To: T10 Technical Committee  
From: Amr Wassal, PMC-Sierra (amr\_wassal@pmc-sierra.com)  
Date: 7 July 2006  
Subject: 06-324r0 SAS-2 modifications to the SAS Speed Negotiation

### **Suggested changes to chapter 6 (Phy Layer)**

Figure 132 — SP (phy layer) state machine - SAS speed negotiation states (continued)

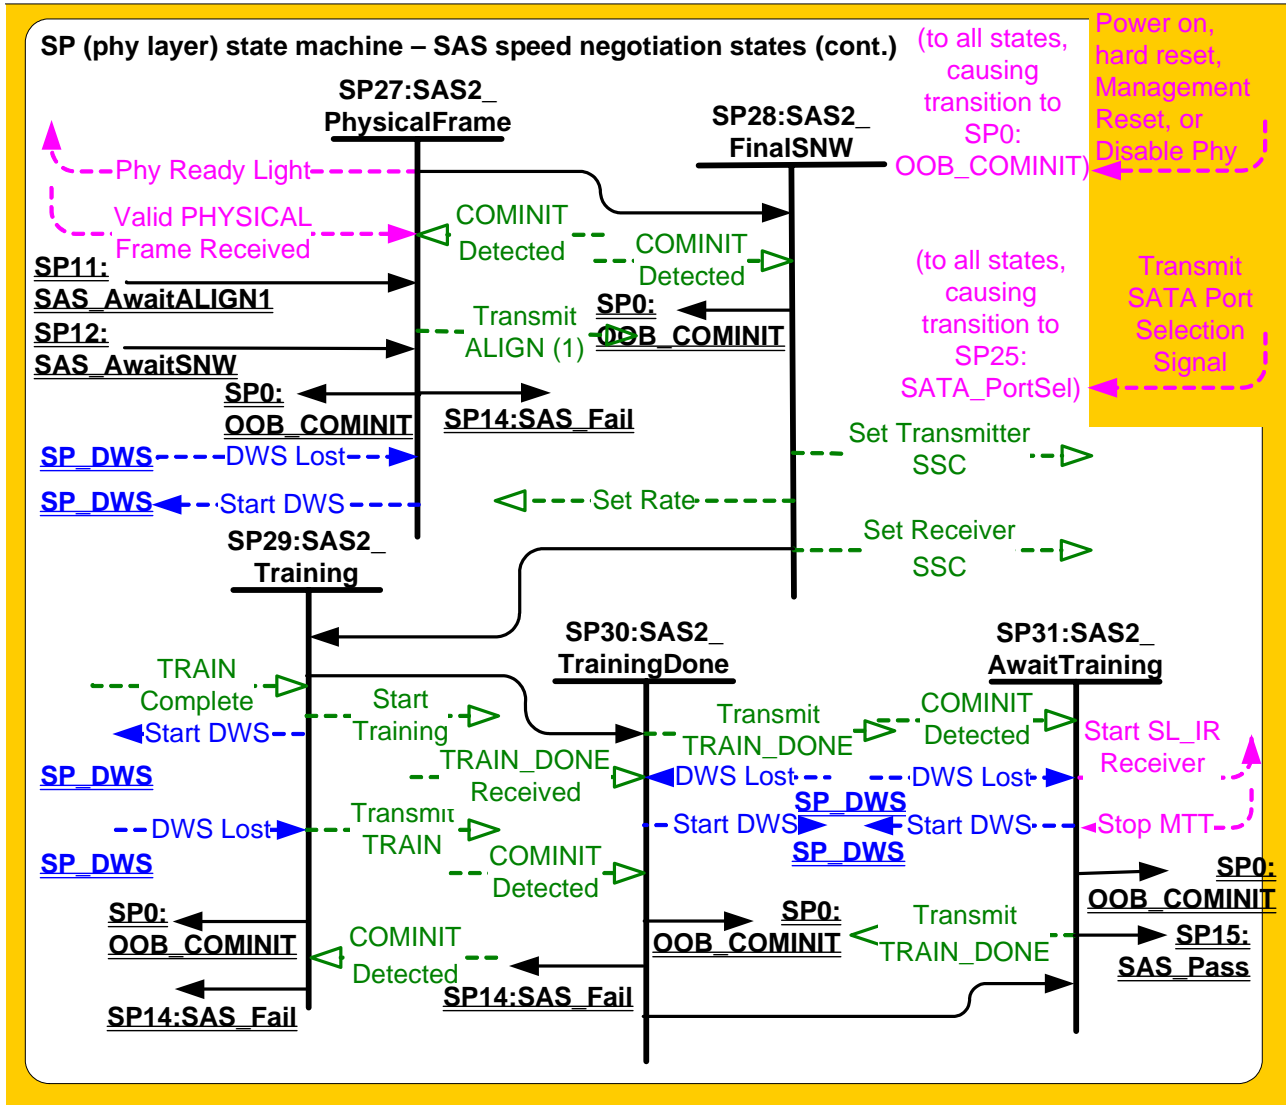
Figure 132 shows the rest of the SAS speed negotiation states related to SNW-3 and the SNW-Final speed negotiation windows. These states are indicated by state names with a prefix of SAS2.
